US DEPARTMENT OF ENERGY
HANFORD WASTE VITRIFICATION PLANT

DESIGN CHANGE NOTICE

DCN - 0111

REMOVE HOLD HWVP-FD-410 FROM COLUMN PIERS

DETAIL 1 2 AS NOTED
119276 119276

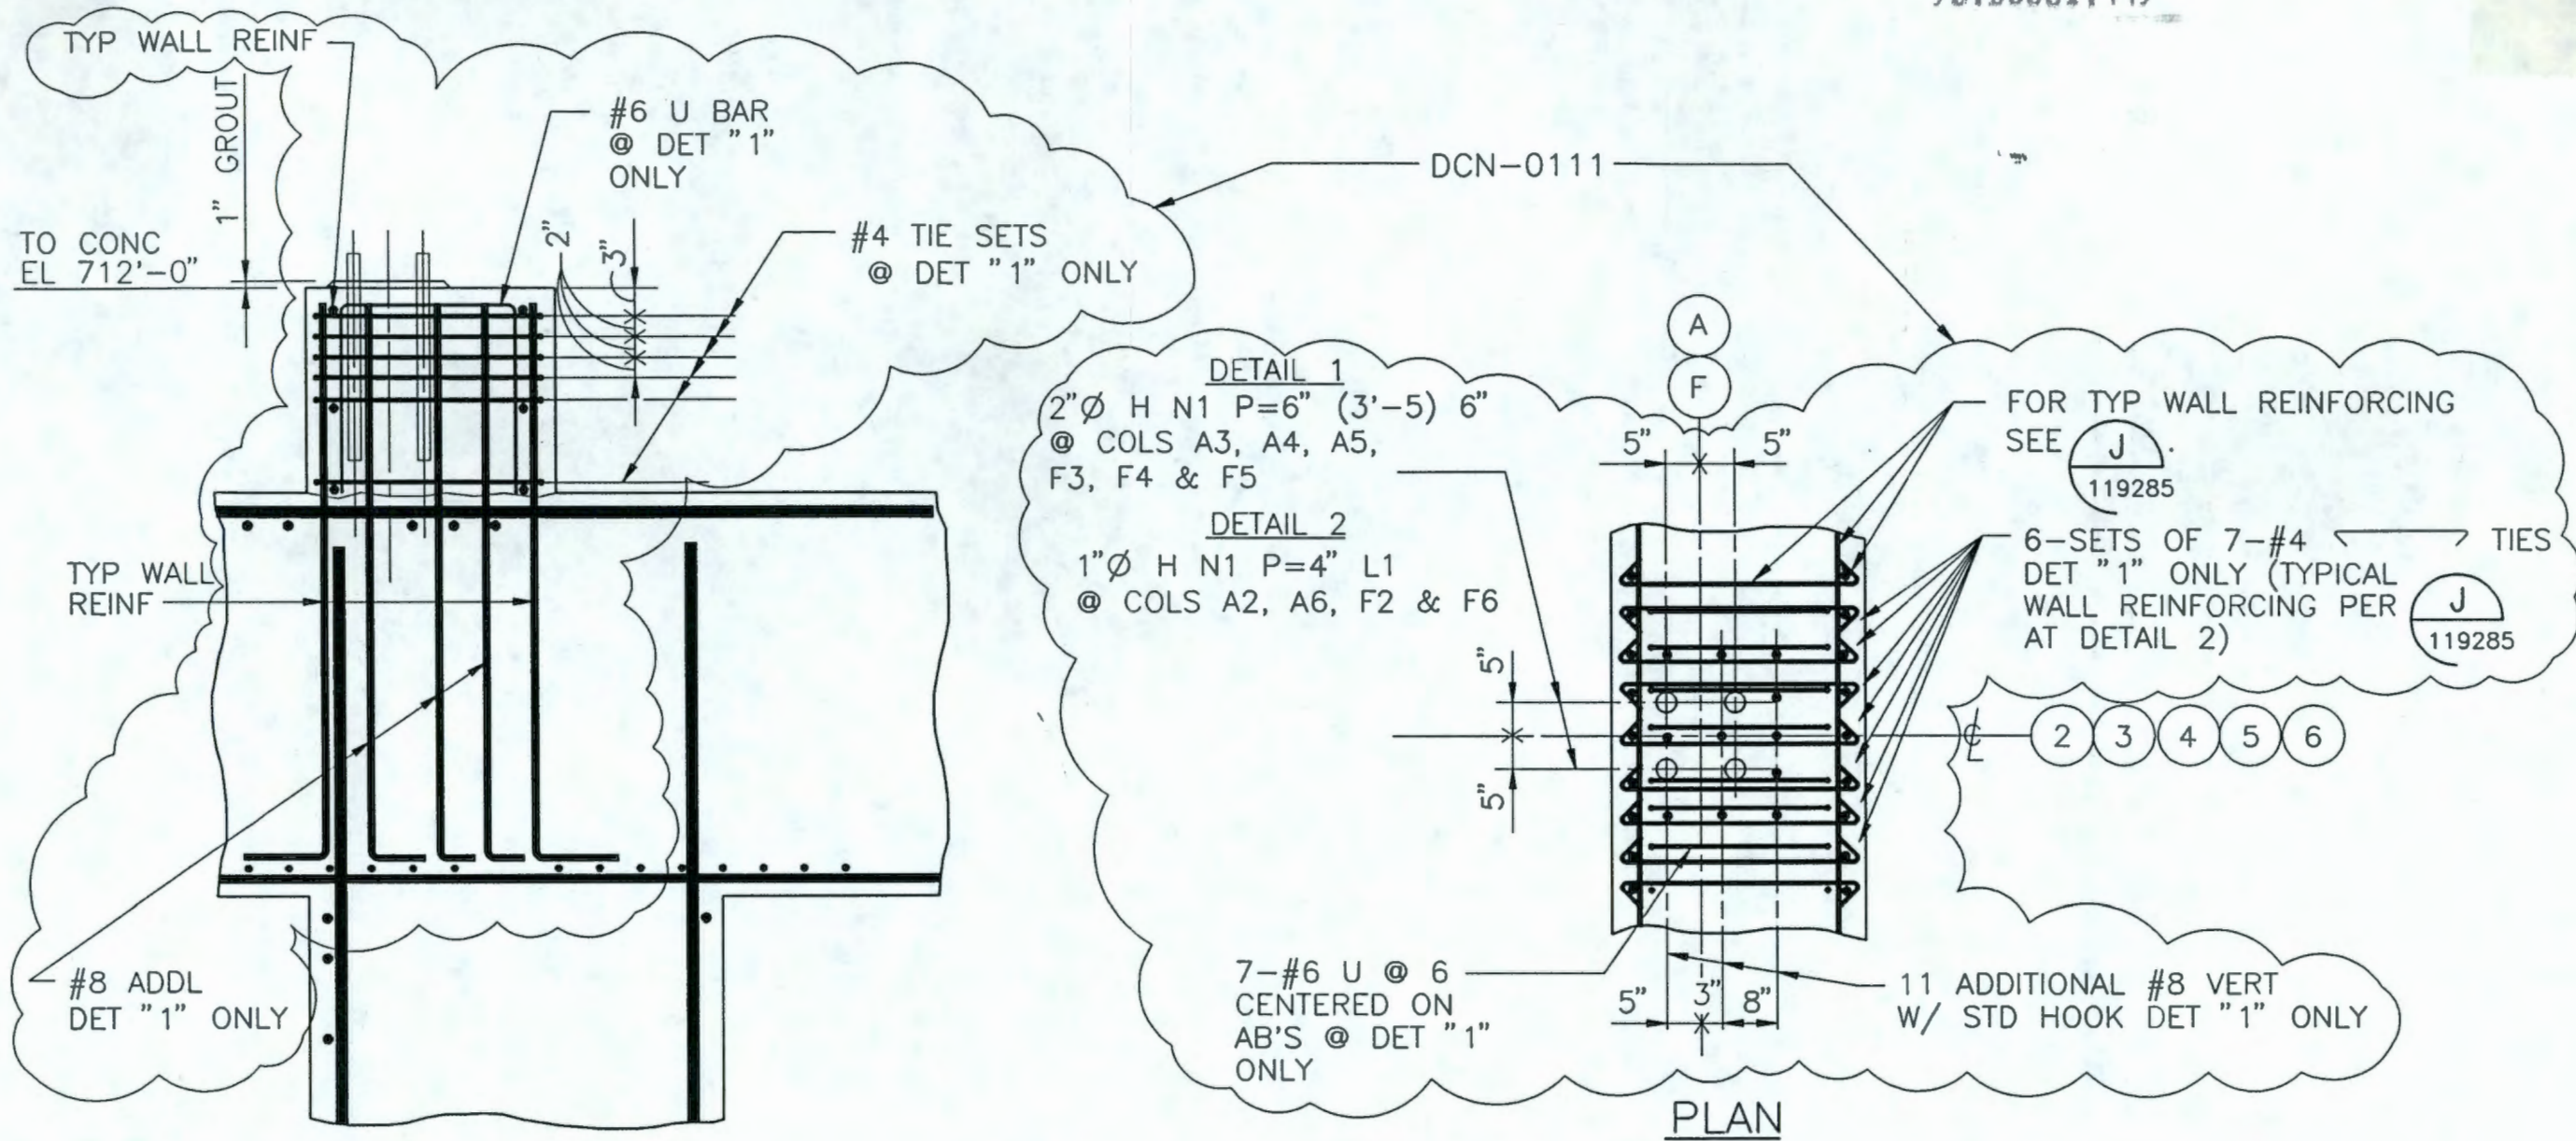
FLUOR DANIEL	U.S. DEPARTMENT OF ENERGY HANFORD WASTE VITRIFICATION PLANT		DESIGN CHANGE NOTICE	
	DESCRIPTION OF CHANGE REMOVE HOLD HWVP-FD-410 AND REVISE REINF AND ANCHOR BOLTS.		BASE DOC. NO. H-2-119283	SHT/PG. 1 REV. 1
PREPARED BY: <i>Armando Vellega</i>		DATE: 10/14/93	CR NO. CR-HWVP-1025	
DISCIPLINE ENGINEER: <i>Ralph J. Smith</i>		DATE: 10/14/93	DISCIPLINE: STRUCTURAL/DCN0111C	
DCN - 0111			REV. 0	PAGE 3

DETAIL **5** **6** AS NOTED

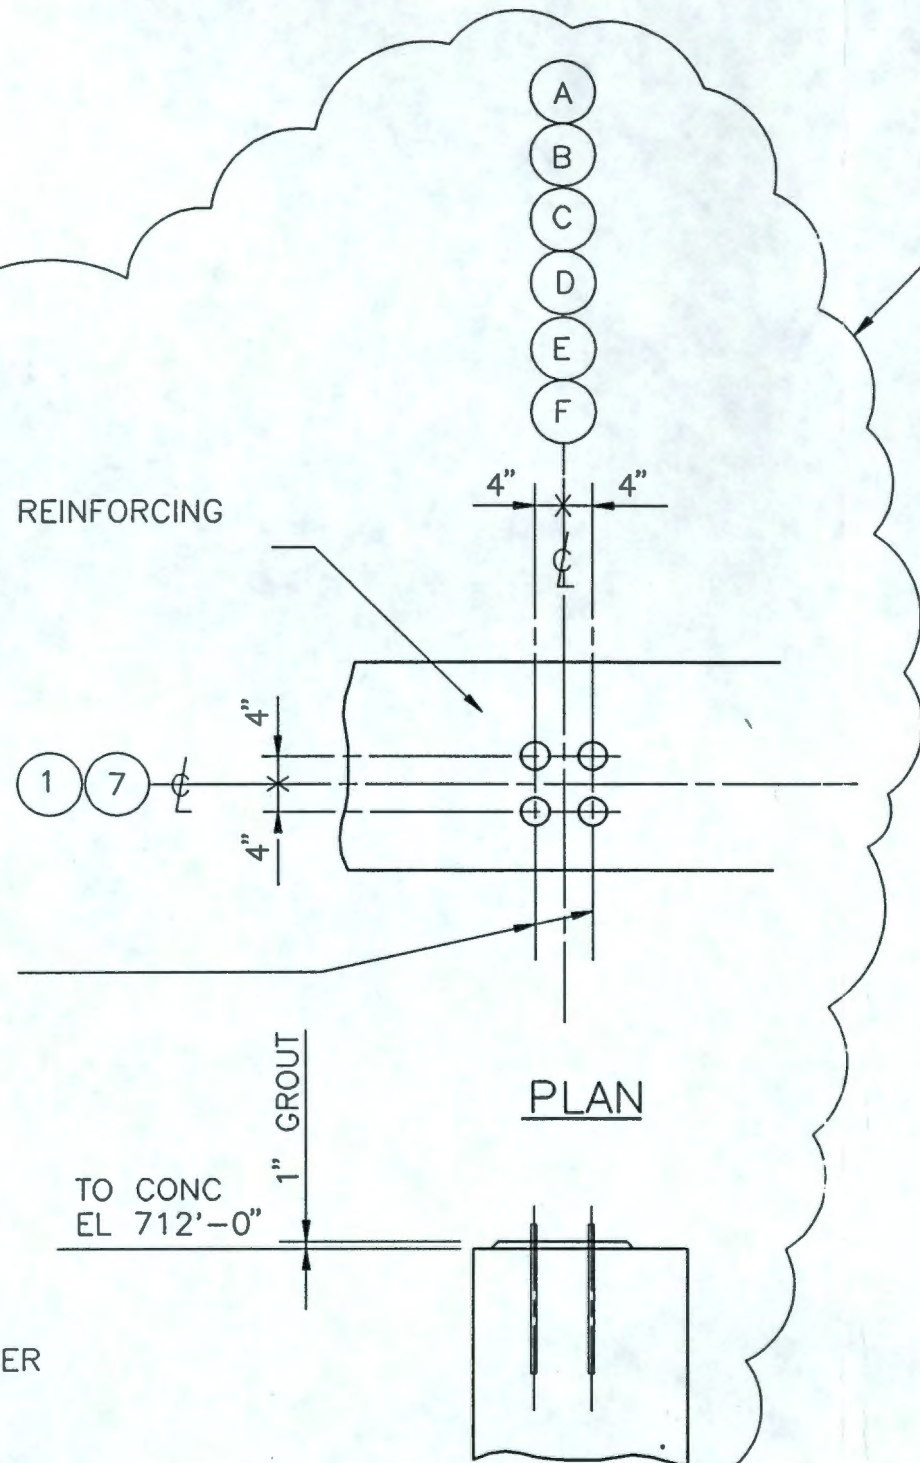
2"Ø H N1 P=6" (3'-5) 6"
@ COLS B1, C1, D1,
B7, C7 AND D7
(FOR REINF @
2"Ø BOLTS SEE
DET "1" THIS DWG)

1"Ø H N1 P=4" L1
@ COLS A1, E1, F1,
A7, E7 AND F7
(TYPICAL WALL REINFORCING PER
J, AT DETAIL 6)

FLUOR DANIEL	U.S. DEPARTMENT OF ENERGY HANFORD WASTE VITRIFICATION PLANT		DESIGN CHANGE NOTICE	
	DESCRIPTION OF CHANGE REMOVE HOLD HWVP-FD-410 AND REVISE ANCHOR BOLTS		BASE DOC. NO. H-2-119283 SHT/PG. 1 REV. 1 CR NO. CR-HWVP-1025 DISCIPLINE: STRUCTURAL/DCN0111D	REV. 0 PAGE 4
PREPARED BY: <i>Armando Villegas</i>	DATE: 9/29/93	DISCIPLINE ENGINEER: <i>Robert D. Order</i>	DATE: 9-29-93	DCN - 0111
